Dolby Laboratories Inc

Field Bulletin 185

Cat. No. 249A Modification To Increase Immunity To Going Into Bypass

figure 1 - Cat.No.249A PCB - resistor changes

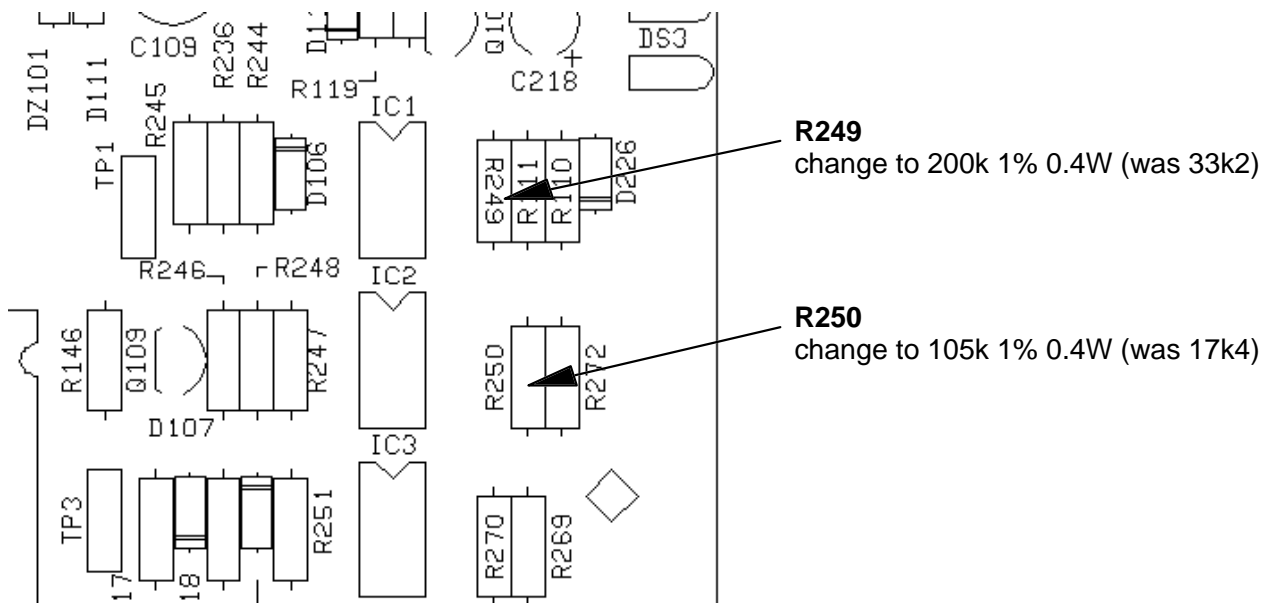
Fault Symptom: Model CP65 goes into Bypass mode, caused by interference, for example from Xenon lamps.

Reason: The op-amp IC1b on the Cat.No.249A, type LM358, may latch up (some manufacturers' components only).

Modification: Change two resistor values R249 and R250. See Figure 1. The change to eliminate this potential problem was incorporated into all units manufactured after August 1995 with the introduction of Cat.No.249A Rev 6. All earlier revisions of Cat.No.249A may require modification - the revision number of the PCB can be found on the lower edge of the solder side of the PCB.
